CITY OF FORT LAUDERDALE

ADMINISTRATIVE REVIEW COMMENTS

CASE NO. UDP-A25019

CASE	UDP- A25019
PROJECT NAME	Shader Retail
APPLICATION TYPE	Site Plan Level II Amendment
APPROVAL LEVEL	Administrative Review Committee
REQUEST	1,834 Square Foot Addition to Existing 2,543 Square Foot Retail Use
APPLICANT	ACS Flagler, LLC.
AGENT	Nectaria Chakas, Lochrie & Chakas, P.A.
PROPERTY ADDRESS	801 N. Federal Highway
ABBREVIATED LEGAL DESCRIPTION	Progresso 2-18 D Lots 25,26, Less State Rd Blk 252
ZONING DISTRICT	Regional Activity Center - Urban Village District (RAC-UV)
LAND USE	Downtown Regional Activity Center
COMMISSION DISTRICT	2 - Steven Glassman
NEIGHBORHOOD ASSOCIATION	Flagler Village Civic Association
SUBMITTED	April 11, 2025
COMPLETENESS ISSUED	February 13, 2026
STATE STATUTE 166.033 EXPIRATION	June 13, 2026 (120 Days)
CASE PLANNER	Nancy Garcia, Urban Planner II

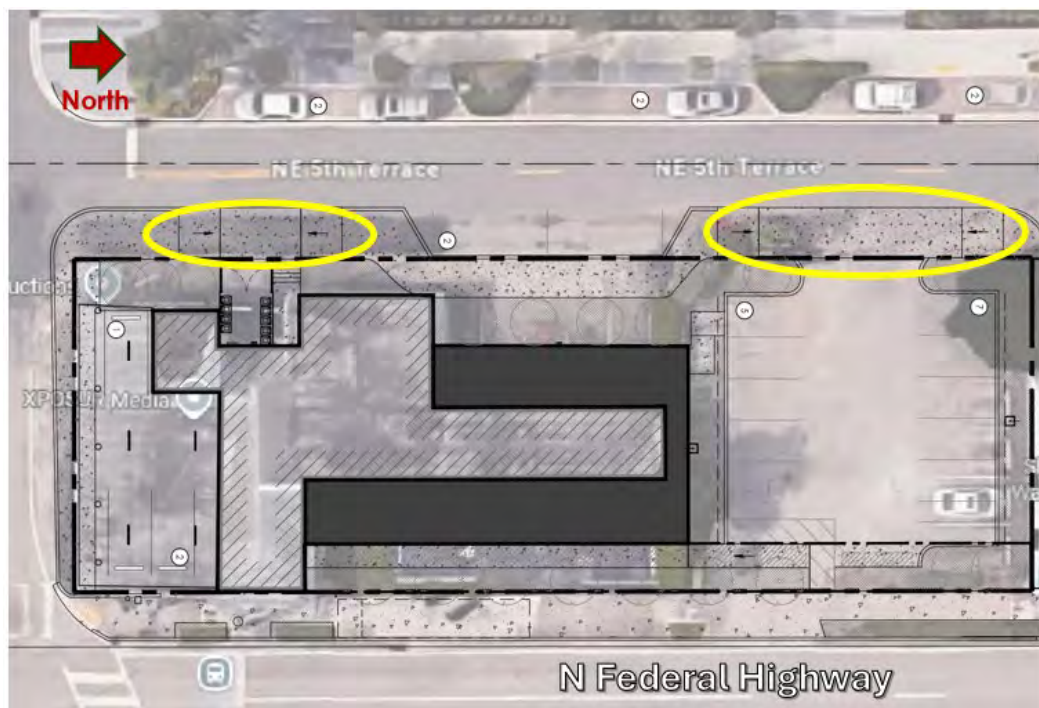
- a. S3- Sidewalk cannot slope near on-street parking. See image below as a reference:

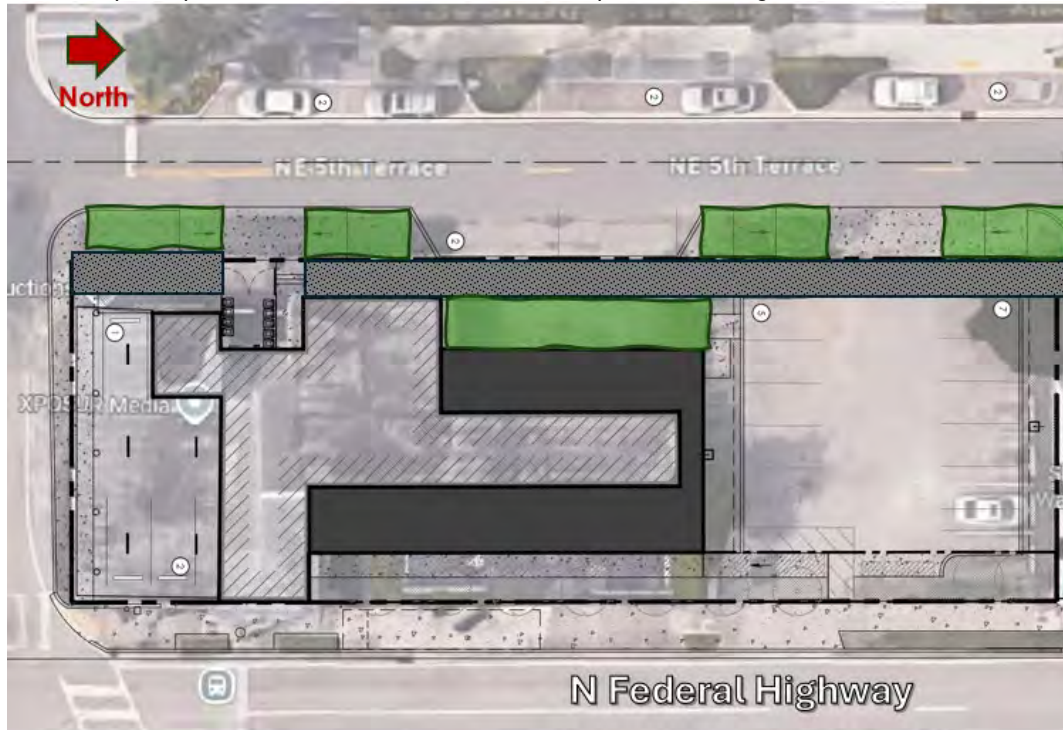
- c. S6- Landscaping and sidewalk along NE 5 Terrace should be flipped to better meet the streetscape requirements of the Downtown Masterplan. See image below as a reference:
